COUNCIL ASSESSMENT REPORT

Panel Reference	PPSSCC – 551
DA Number	DA-24-00133
LGA	Blacktown
Proposed Development	Residential development of the site in 3 stages. Stage 1 - Subdivision into 2 super lots, including demolition of the existing dwelling and structures, remediation, tree clearing, construction of roads, drainage and services infrastructure works. Stage 2 - Community Title subdivision of proposed Lot 2 (in Stage 1) into 1 Community Title lot and 27 residential lots. Stage 3 - Construction of 2 residential flat buildings containing 104 apartments over basement car parking on proposed Lot 1 (in Stage 1). The application also proposes to vary the road pattern under the Indicative Layout Plan.
Street Address	95 Schofields Road, Rouse Hill
Applicant/Owner	Anthony Mancone
Date of DA lodgement	17 April 2024
Number of Submissions	0
Recommendation	Approve, subject to deferred commencement consent, including conditions listed in attachment 9.

1.1 DA-24-00133
Assessment report to
Sydney Central City Planning Panel

Panel reference: PPSSCC-551

Figure 1 - Surrounding road network to be constructed under SPP-21-00006

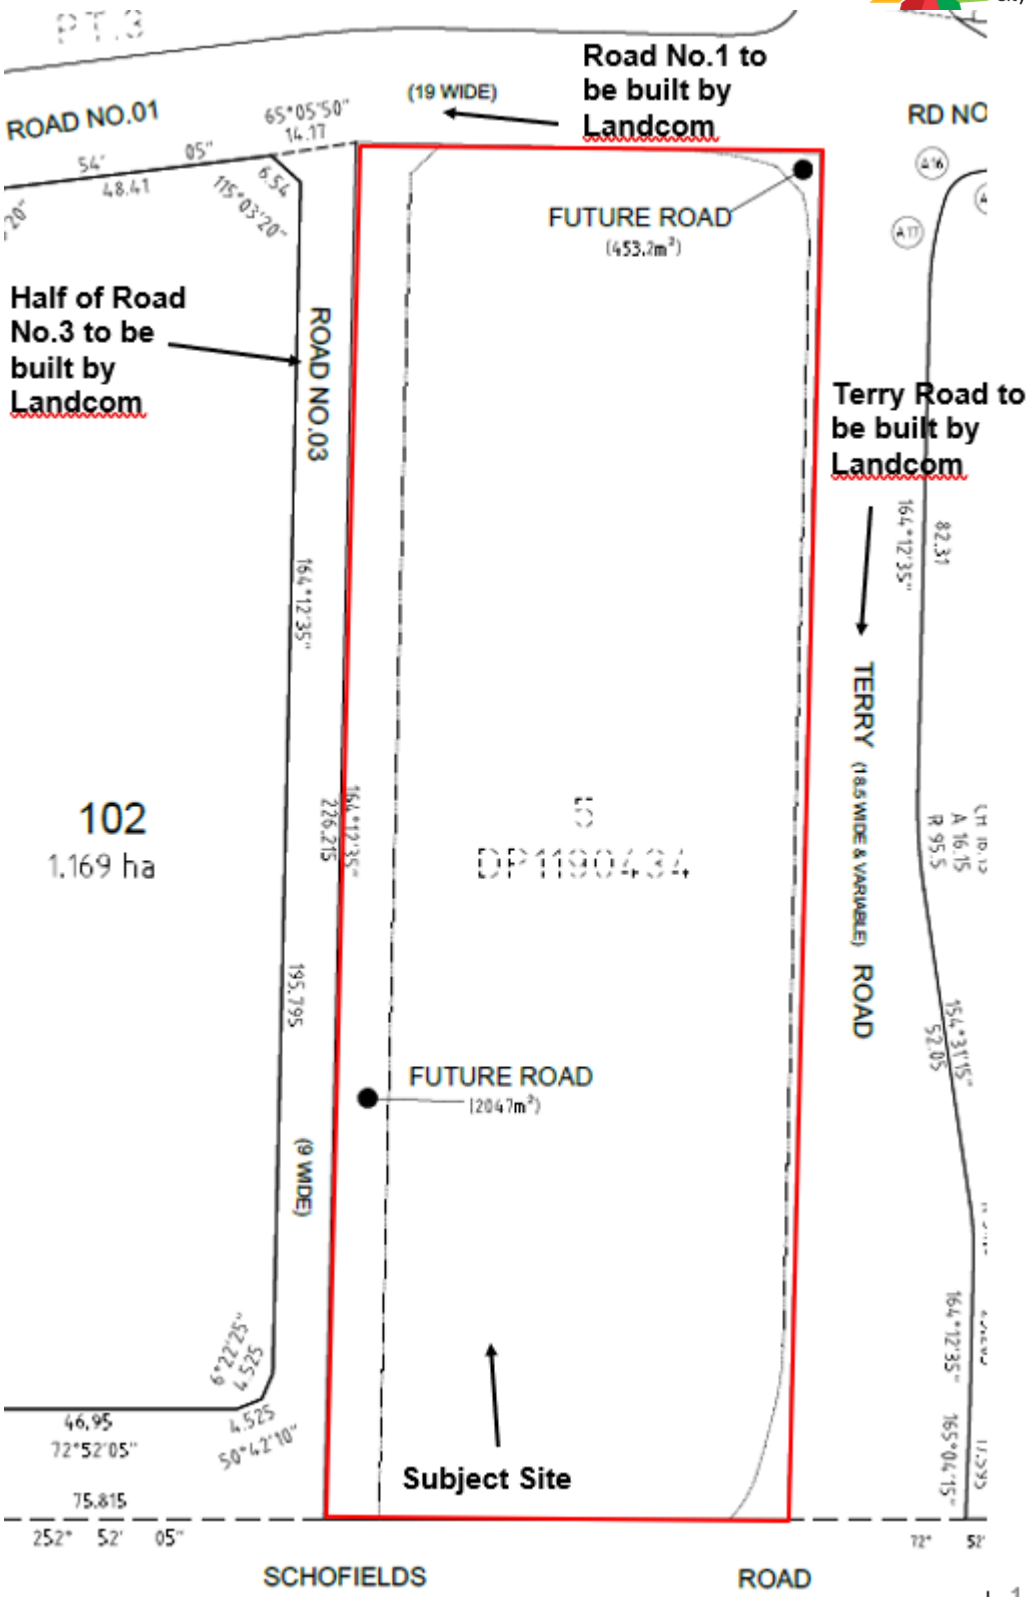
8.1.1 The development relies on the surrounding road network (approved under SPP-21-00006 to be constructed by Landcom) to achieve public road access to the proposed access points. These roads include the construction of an extension to Terry Road to the east of the site and a local public road along the site's northern boundary (Road No.1 in Figure 1 below from the approved plans of SPP-21-00006).

8.1.2 This applicant proposes half road construction of the public local road along the site's western boundary to complete the full width of Road No.3. This completed road will connect to Road No. 1. The proposed private community title road that will service the community title subdivision will also connect to Road No 1. In the absence of Road 1 being completed by Landcom, no public road access to the land is possible as Schofields Road is an access-denied road.

8.1.5 We don't support this approach as it is not orderly planning. Our position remains that all the works in SPP-21-00006 must be completed prior to this consent becoming operational. There is no certainty on when the Landcom works will be delivered, so it would be premature for this development to commence before the Landcom works when it is so heavily reliant on Landcom for all its access and drainage needs.

DA2 - 101
DRAWING No.

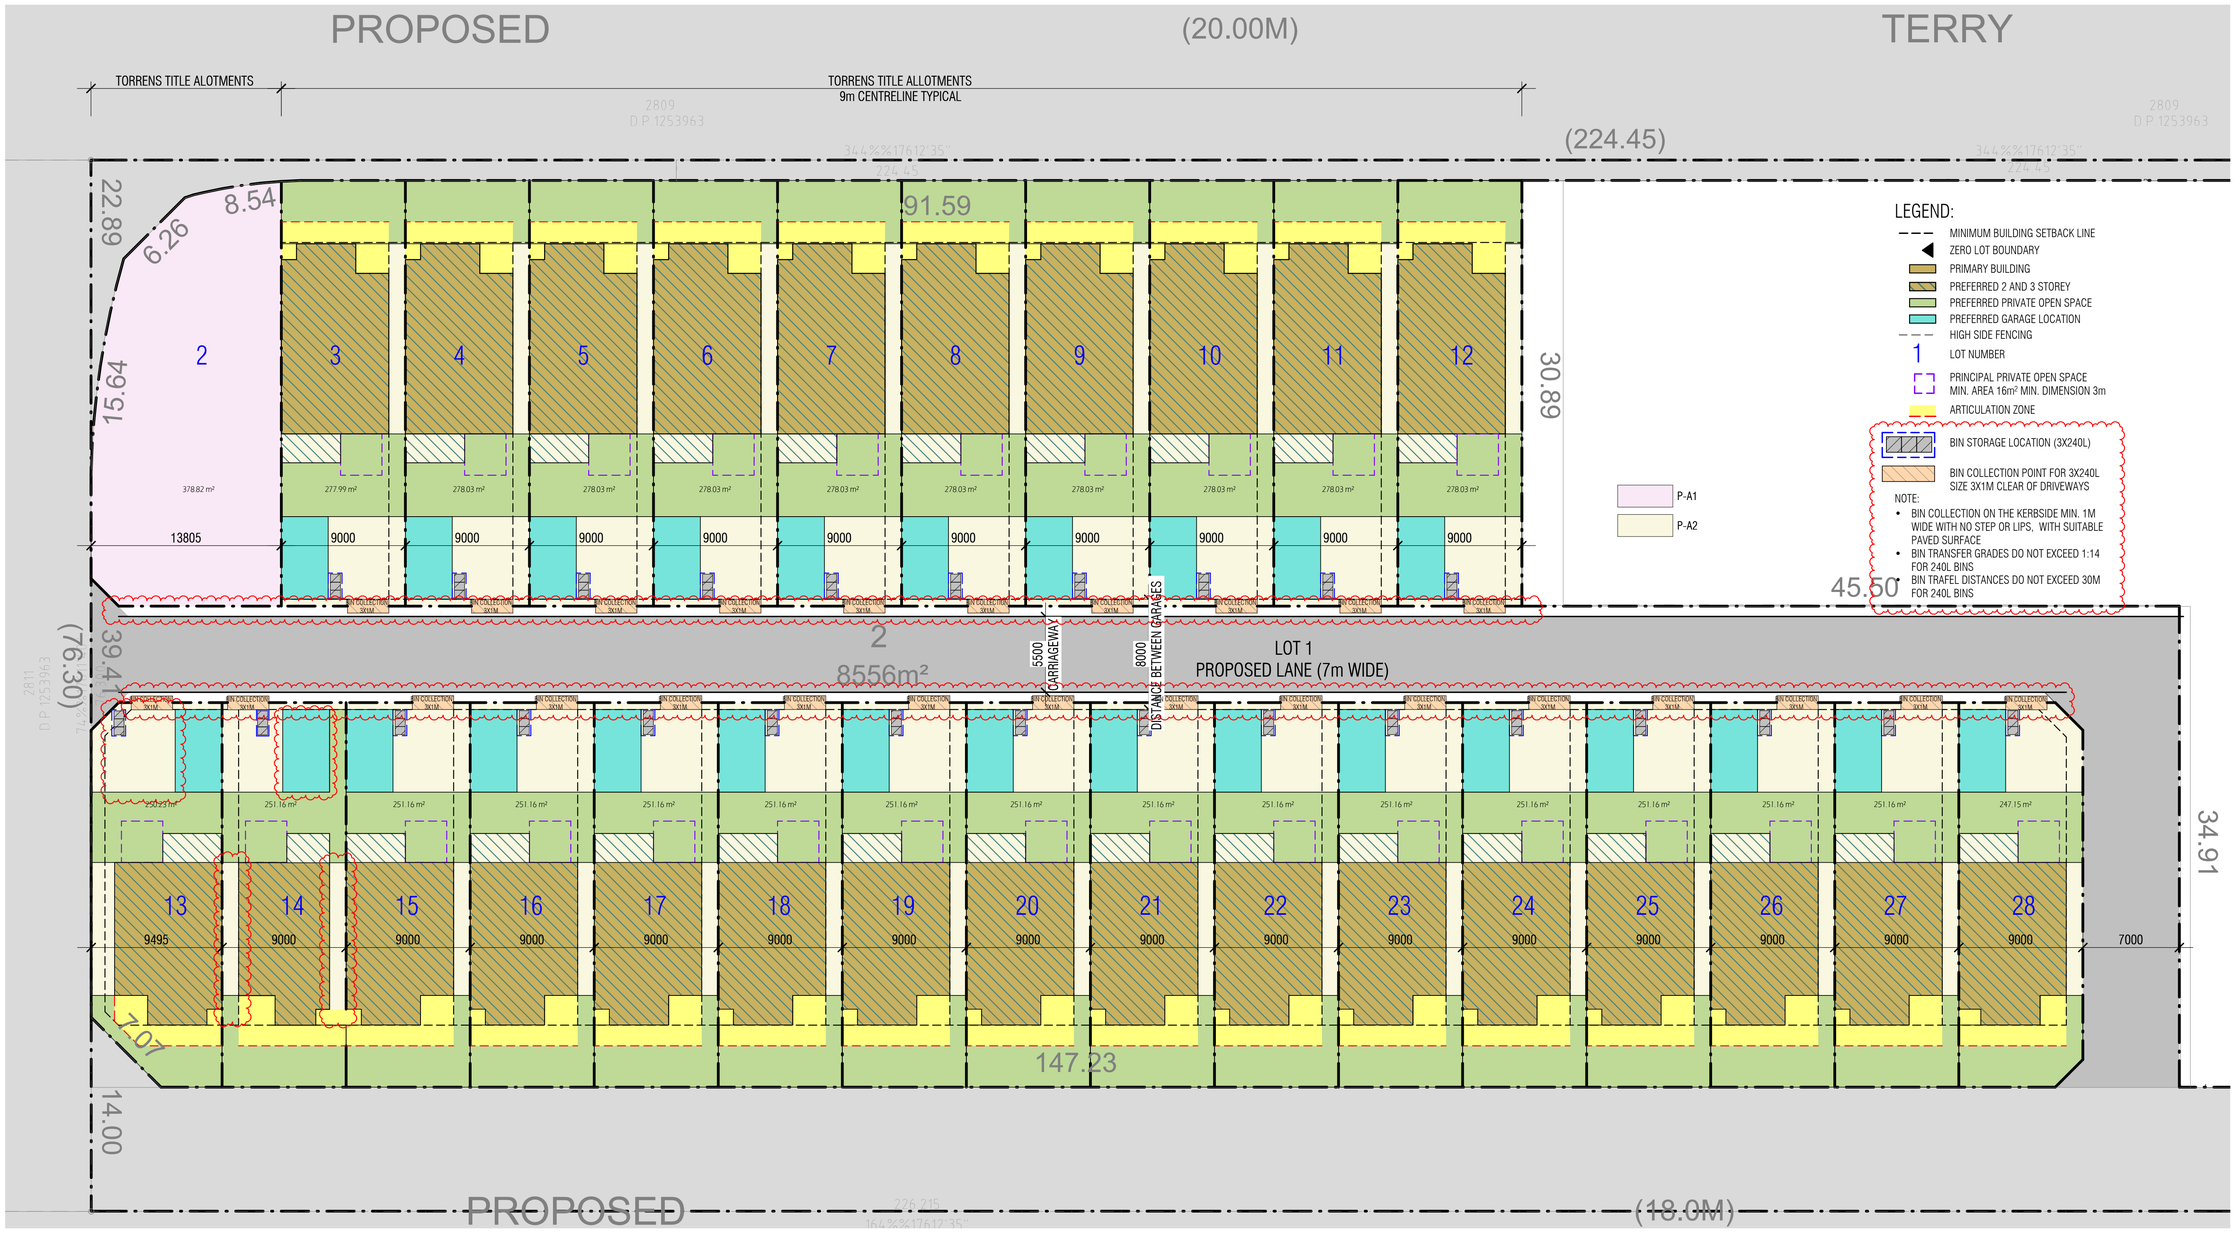
NOTE ISSUE C:
- DRAWING AMENDED TO SHOW BIN COLLECTION POINT ON EACH DWELLING
- SETBACK FOR LOT 14 INCREASED TO 1.2M
- BIN COLLECTION ON THE KERBSIDE MIN. 1M WIDE WITH NO STEP OR LIPS
- NOTE ON LEGEND AMENDED
